**DATE:** September 9, 2009  
**TO:** Prospective Bidders  
**RE:** Addendum #1 to the Bidding Document for  
Addition to the Early Childhood Center  
Lindale I.S.D.  
Lindale, Texas

ADDITION TO THE  
EARLY CHILDHOOD  
CENTER

ADDENDUM No. 1

### PARTIAL REVISED FLOOR PLAN

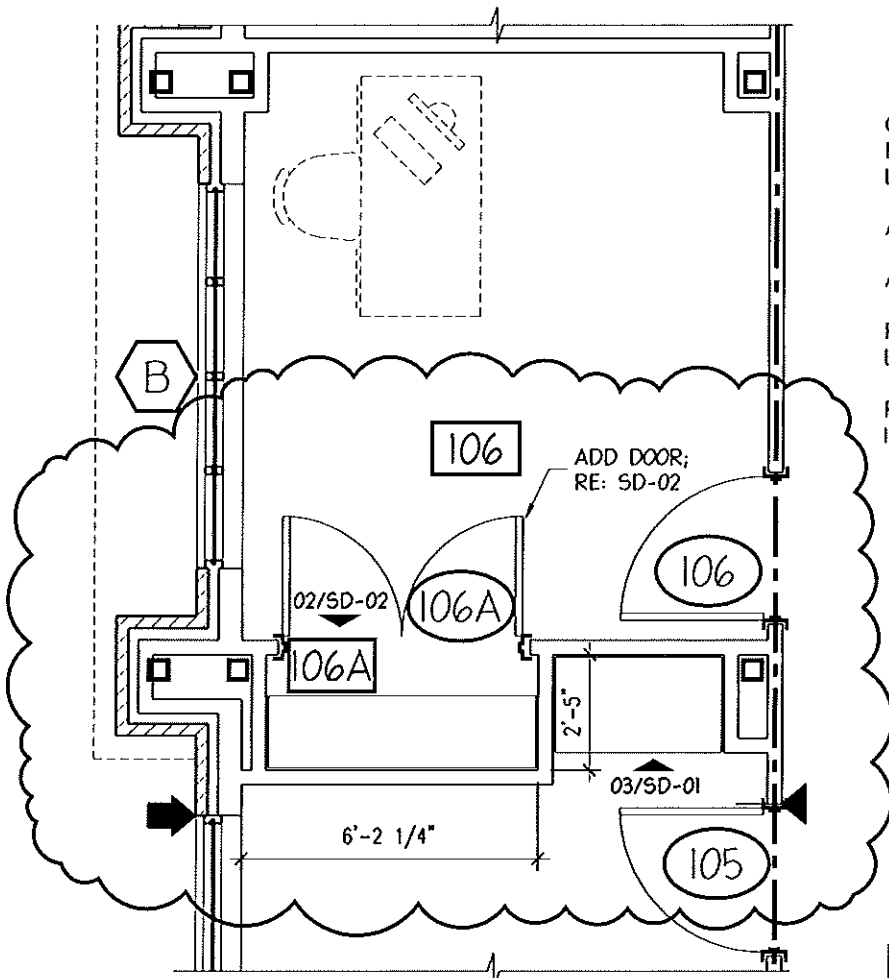
**Sheet A2.0 – A2.3, A3.0 & A5.0:** Refer to attached SD-01 & SD-02 for closet (w/millwork) added to Room 106.

ADD NEW ROOM 106A - CLOSET

ADD NEW DOOR 106A
